AMENDMENTS TO THE DRAWINGS

REMARKS

Fig. 1

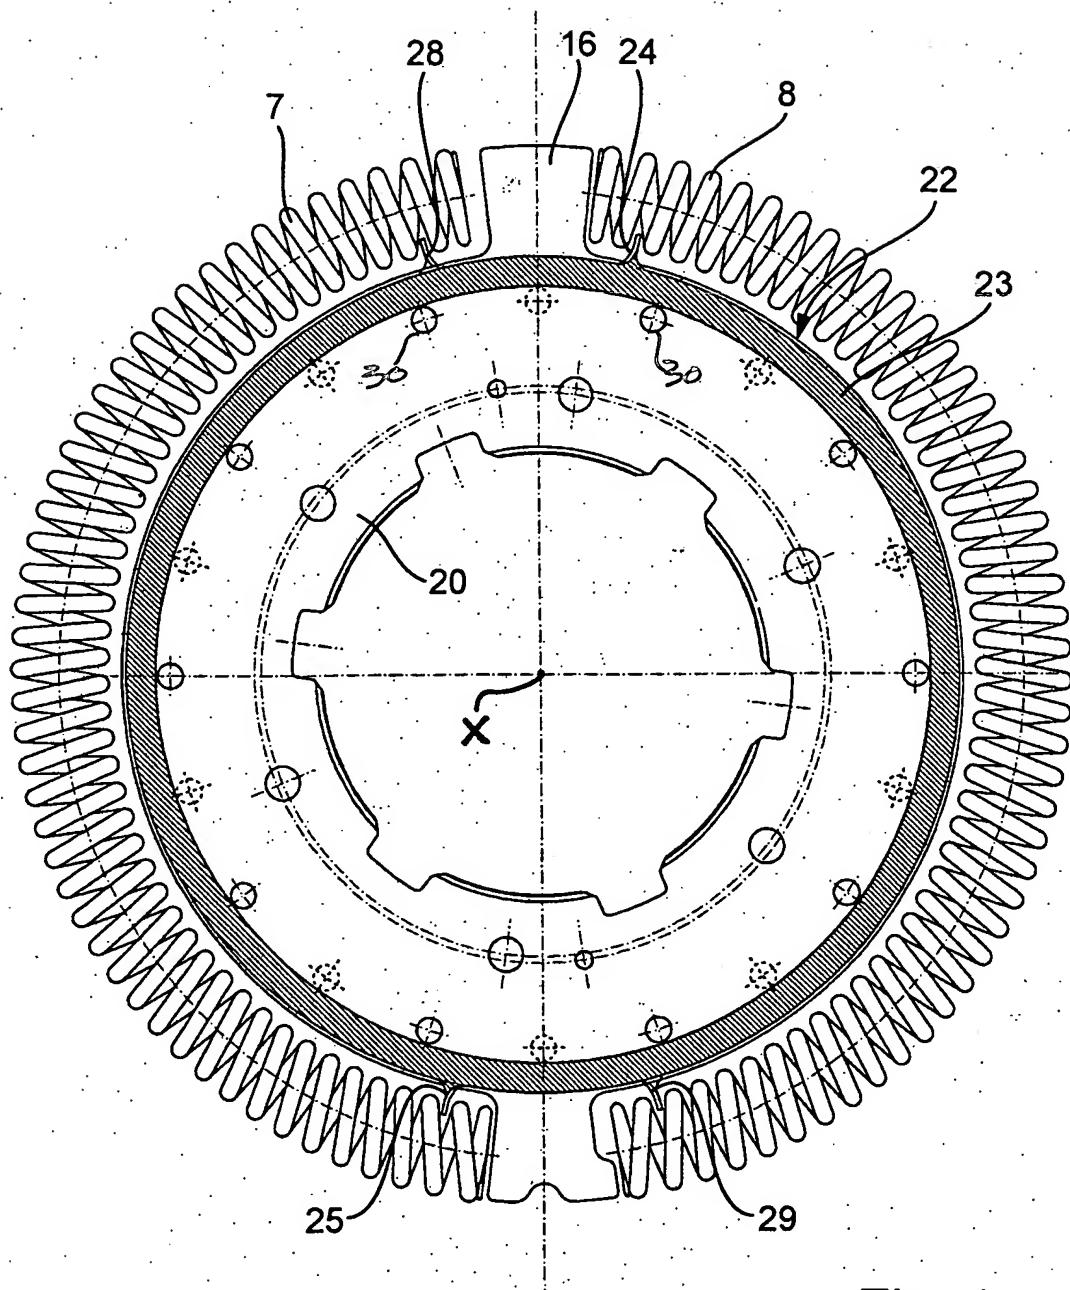
The sheets of drawings appended hereto include marked-up copies of originally-filed Figures 1 and 2 showing proposed changes in red. The proposed change to Figure 1 involves the addition of reference numeral 30 in two places to identify the rivets that serve as centering elements for annular coupling elements 22, 26, as described in paragraph [0038] of the specification as filed. The rivets support coupling elements 22, 26, so that they are rotatable relative to torque-transmitting support 20 about axis X, as recited in paragraph [0042] of the specification as filed.

The drawings were objected to on the ground they contradict each other. Reference was made to coupling elements 22, 26 and rivets 30 as they are shown in Figures 1 and 2. In that regard, coupling element 22 is defined by and includes carrier element 23 along with entraining member 24 and 25. Similarly, coupling element 26 is defined by and includes carrier element 27 along with entraining member 28 and 29. Moreover, carrier elements 23 and 27 are each annular discs that are centered relative to axis X by rivets 30, as clarified by the changes to Figure 1. The changes to Figures 1 and 2 clarify the structural arrangement of the claimed invention.

Fig. 2

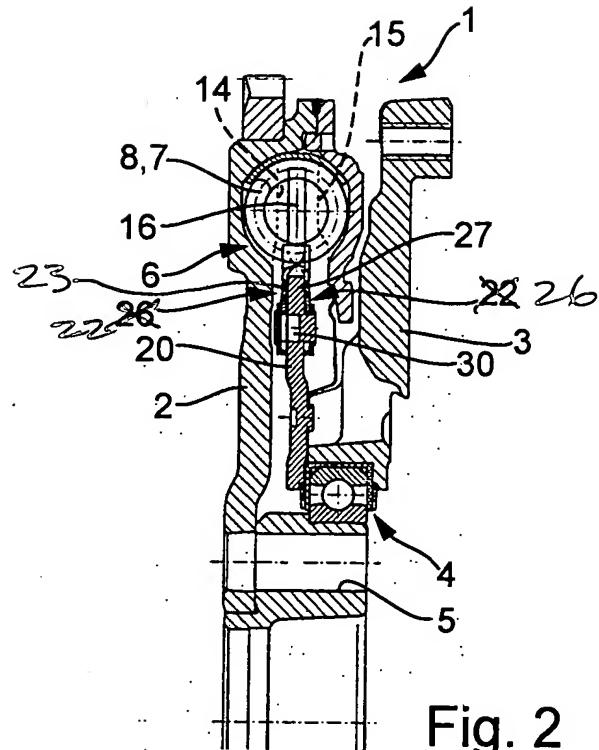
The proposed changes to Figure 2 include the addition of reference numeral 23 to identify the annular, disc-shaped carrier element that together with entraining members 24 and 25 forms coupling element 22. Additionally, original reference numeral 26 has been replaced by reference numeral 22, and original reference numeral 22 has been replaced by reference numeral 26, to conform the drawings with each other and with the specification as amended herein.
